**RE: Pinnacle Bellevue North
Project #: 21-103195-LD; 21-103192-LP
Revision Request #4**

The Development Review Committee (DRC) has reviewed the plans submitted February 27, 2023. Below are additional comments and revision requests from the City's review team. **Please note that additional information may be requested as a result of our review of your resubmittal.**

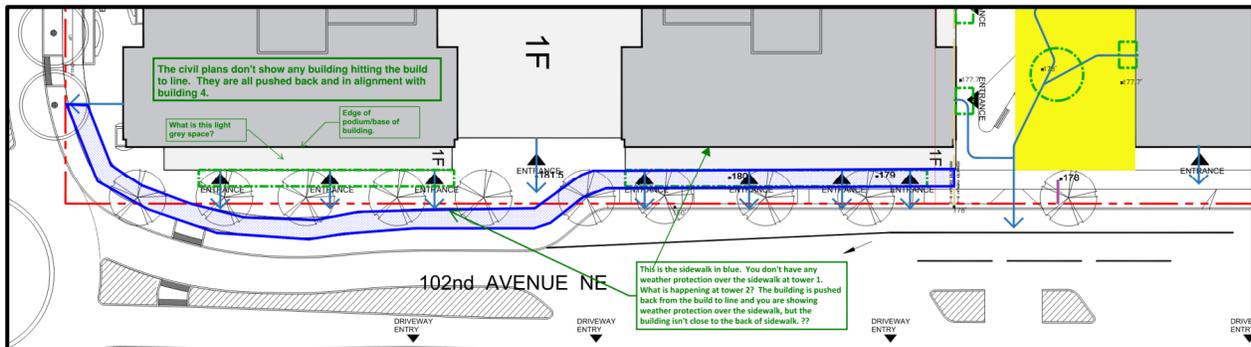
4. The buildings on 102nd Avenue NE do not meet the build to line (back of sidewalk). The architectural drawings are not consistent with the civil drawings, which show towers 1 & 2 and building 4 all pulled back from the build to line at the same alignment. Your build-to line departure is inaccurate when you state that towers 1 & 2 meet the build to line except for the entry point, which is recessed. Refer to comments under Departures. If you do not meet the build to line (back of sidewalk) then you can't provide the required weather protection or meet the ROW guidelines, which means this project isn't meeting the land use code standards on 102nd Avenue NE. Building 4 is an exception since it has to be pulled back to allow for sight distance standards to be met for the driveway. Here is the graphic from the build to line departure:

What can be done in the area between the base of the podium and the back of sidewalk to make this space activating and not just an enlarged sidewalk? Look at the Enhanced Streetscape Amenity. To approve a build-to line departure, you need to demonstrate why this is necessary and show how the proposal is better than strictly meeting the build to line.

5. There isn't any weather protection over the sidewalk on 102nd Avenue NE. The architectural plans are not consistent with the civil plans. Civil plans show buildings 1, 2 & 3 all pulled back from the back of sidewalk. See graphic below.

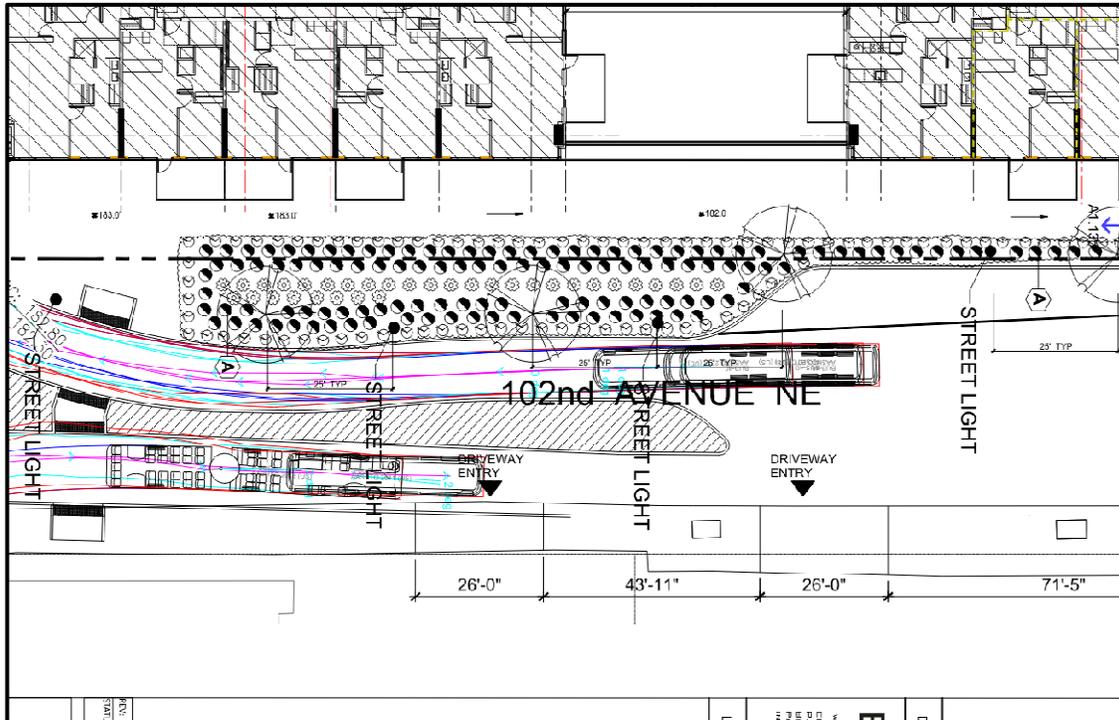
1. Tandem stalls should not be used for commercial retail stalls, as there is no way to manage these. Remove.

If you are proposing tandem stalls for residential uses, then you need to clearly show how many tandem stalls are proposed. Tandem stalls may not be used to meet the minimum parking requirements for residential. You are proposing 56 tandem stalls for residential uses, but you are only showing an additional 28 stalls above minimum for residential (1,452 vs. 1,424). This is not consistent. Unless your parking table is incorrect?

How does a tandem stall work if one is EV charging and the other isn't? Is there enough room to support the EV charging infrastructure with another parking stall to meet width and depth of stall requirements?
